AllUrbanPlanning

11 April 2024

Tasmanian Planning Scheme - Clarence Draft amendment PDPSAMEND-2021-02280 - Apply airport obstacle limitation area overlay to land around Cambridge Airport

Plan 1 – Revised OLS mapping 8 Cherokee Drive (Source: Rogerson & Birch Surveyors)

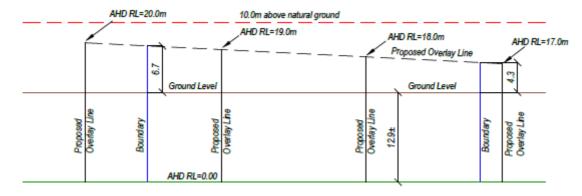
Plan 1 in Appendix A includes the following plan and section diagram that show that the revised OLS will result in a residual or 'buildable' height at 8 Cherokee Drive of between 4.3m to 6.7m above existing ground level.

In my assessment the revised OLS would prevent development of the 8 Cherokee Drive for a typical light industrial warehouse style building.

Andrew Birch has advised (see blue notes in the bottom right corner of Plan 1 in Appendix A) that on his calculations the height limitation model would need to shift:

- 100m eastward to maintain a 'buildable' height of 9m above the ground level of 8 Cherokee Drive or
- 120m eastward if it were to maintain a 'buildable' height of 10m at 8 Cherokee Drive.

Section 1 – Impact of revised OLS on 8 Cherokee Drive (Source: Rogerson Birch)

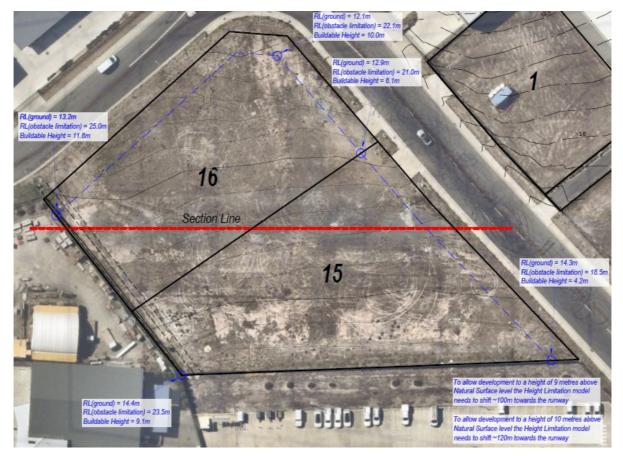
I note that the adjacent building on 6 Cherokee Drive (lot 2 on Plan 1) has a roof height of RL 20.4m as shown on Plan 3. I estimate that this building has a height of approximately 8m above ground level.

Prive	LAN 3
Difference in Height = +4.2m	
	Elen «
- existing buildings	Reference: AIRIN03 Date:
	8-4-2024 Scale:
	1:1000 (A3)

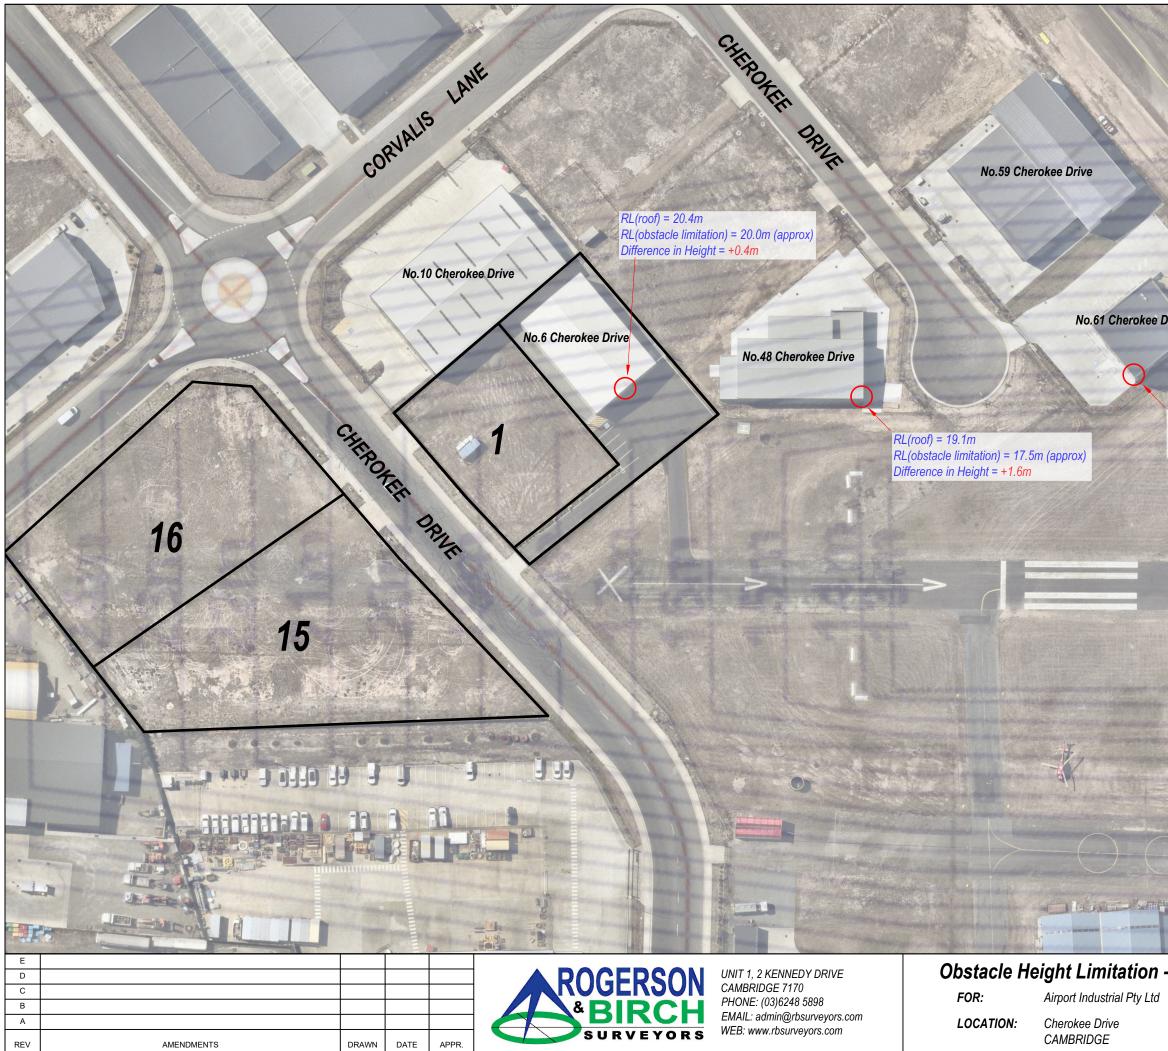
It is my understanding that Plan 3 demonstrates that the existing buildings on the developed lots at No.s 6, 48 and 61 Cherokee Drive would exceed the OLS overlay if it was approved, noting of course that the development of those lots has already occurred and the existing development will not be impacted by the proposed OLS per se. The fact that there is already some developed lots that exceed the OLS overlay heights seems to in some ways put to question the OLS's utility. I note in particular that No.61 Cherokee Drive is 4.2m above the revised OLS.
